DART SERVICE INSTRUCTION

TO AMEND INSTALLATION INSTRUCTIONS IIN-D505-1057 REV. B,
INSTALLATION INSTRUCTIONS II505-1 REV. E,
INSTRUCTIONS FOR CONTINUED AIRWORTHINESS ICA-D505-1057 REV. 1,
AND INSTRUCTIONS FOR CONTINUED AIRWORTHINESS ICA505-1 REV. 3
OR LATER APPROVED REVISIONS
REF. TCCA STC: SH18-9, SH19-31
REF. FAA STC: SR04133NY, SR04387NY
REF. EASA STC: 10067422, 10070898
REF. DGAC MEXICO STC: IA-623/2019, IA-645/2019

1.0 PURPOSE

FIGURE 1: LOOP CLAMP AND L-BRACKET ATTACHMENT LOCATIONS

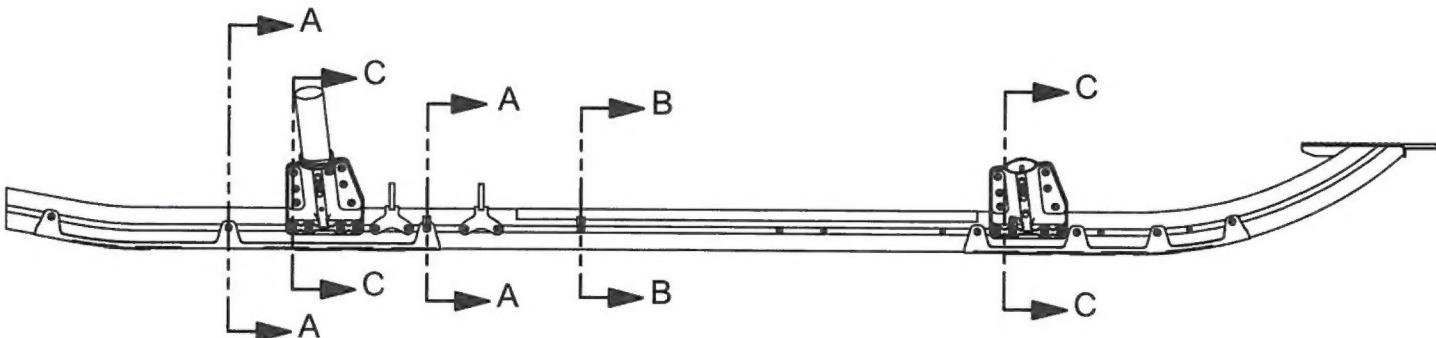
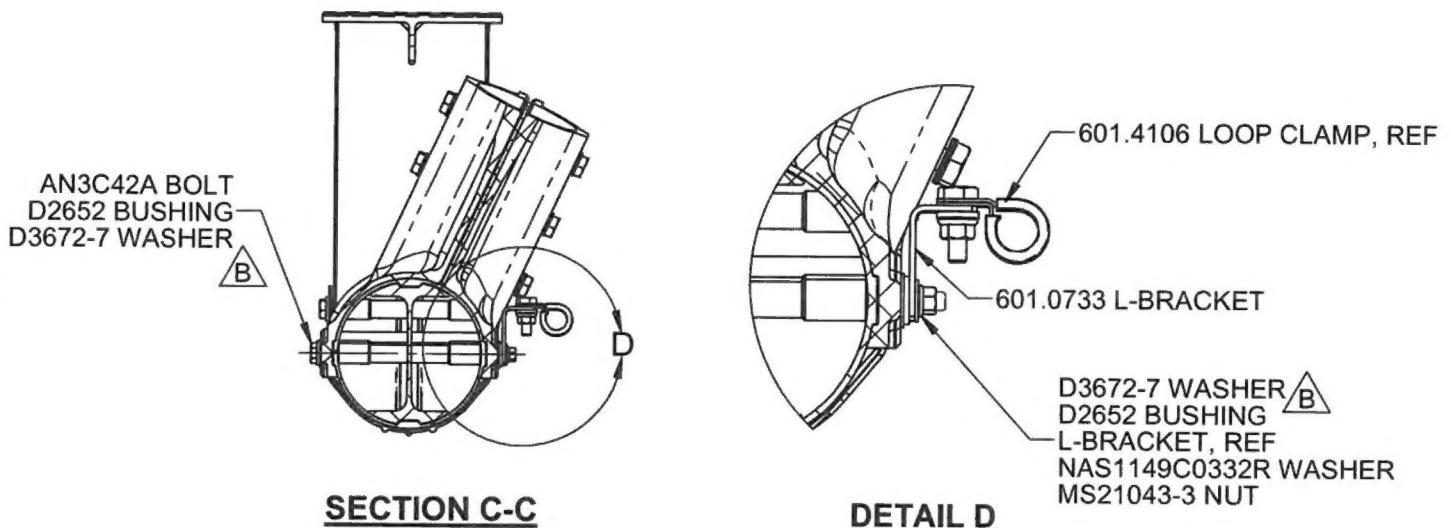
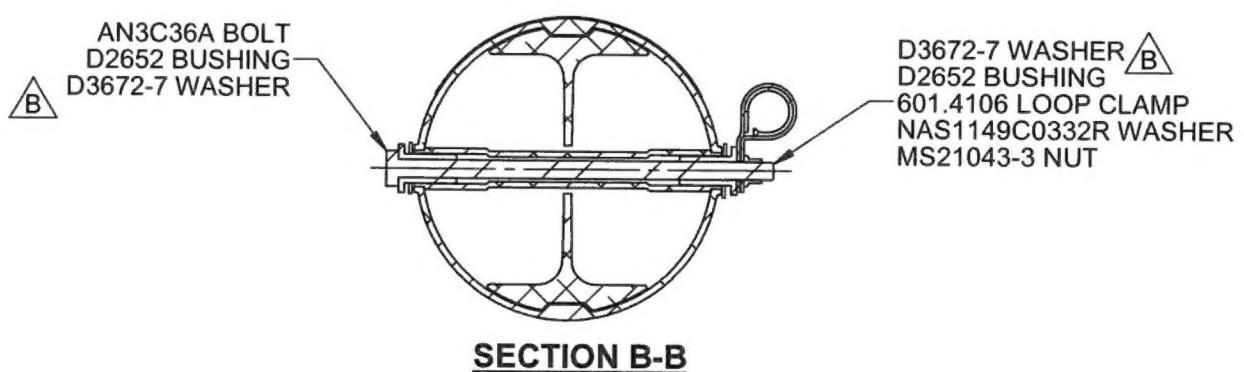
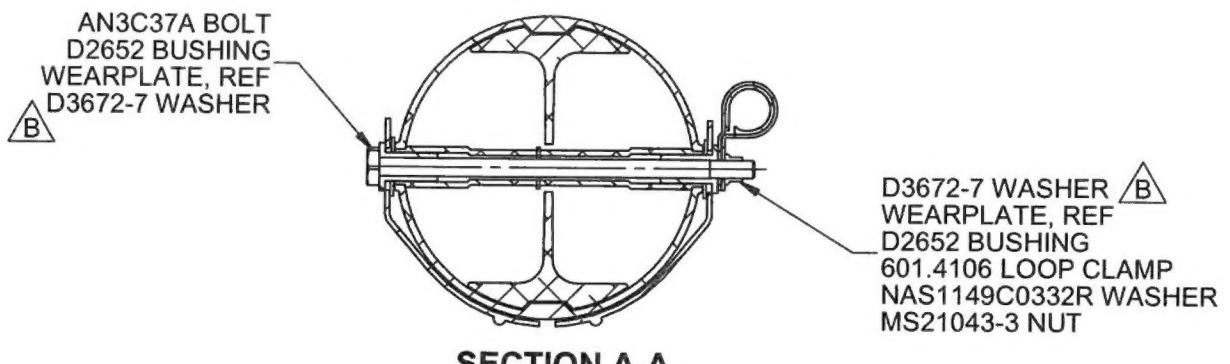
2.0 CHANGE: RELOCATION OF LOOP CLAMP AND L-BRACKETS

When installing the 651.600X-series Emergency Float System on a DART D505-1057-013/-014/-113/-114 Skidtube Installation, Figure 1 of this DSI may be used for alternate Loop Clamp and L-Bracket locations as follows:

- i) 601.4106 Loop Clamps (F/N 25) may be located as shown in Figure 1 and Sections A-A & B-B
- ii) 601.0733 L-Brackets (F/N 51) may be located on the saddles at one of the saddle-to-skidtube bolt locations as shown in Figure 1 and Section C-C.

The section views give suggested bolt lengths for each location. Longer or shorter bolts and additional washers may be used to ensure 1.5-2 threads in safety. Torque the AN3 bolts 20-25in.lbs (2.3- 2.8 N.m). If required, touch-up paint finish with chemical film material (Alodine 1200 or 1201) per MIL-C-5541, one coat of MIL-P-85582 or MIL-P-23377 primer, and 2-3 coats of MIL-C-83285 polyurethane paint to match original finish.

FIGURE 2

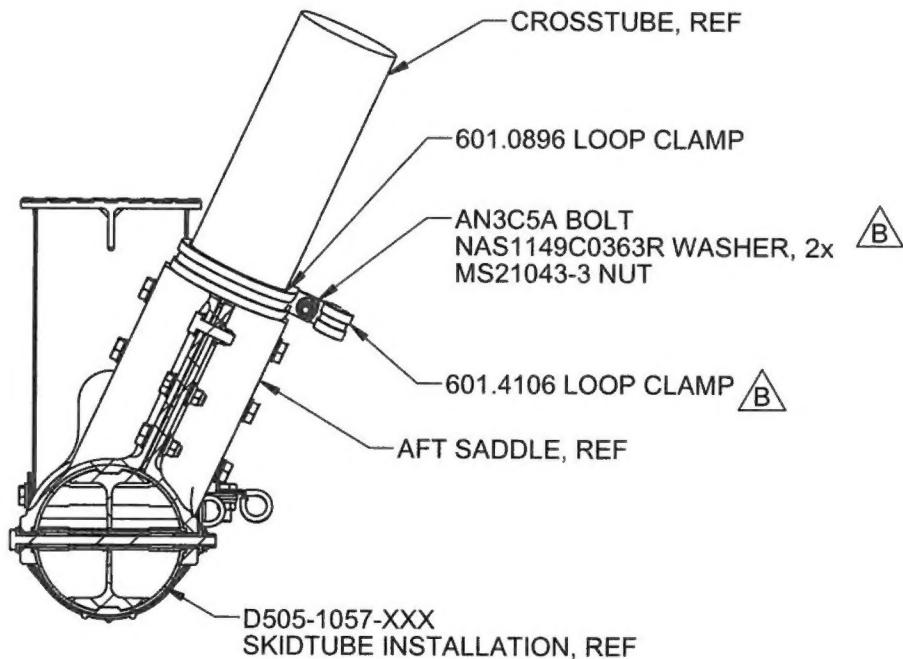
3.0 CHANGE: L-BRACKET REPLACEMENT ON AFT SADDLE

The 601-0733 L-Bracket (F/N 51) shown in Figure 31 of II505-1 will not install on the aft saddle of DART D505-1057-XXX Skidtube Installations. Alternately, install an additional 601.0896 Loop Clamp (F/N 24) at the location shown in Figure 2 of this DSI. Install the 601.4106 Loop Clamp (F/N 25) and associated hardware similar to Section P-P of Figure 30 of II505-1.
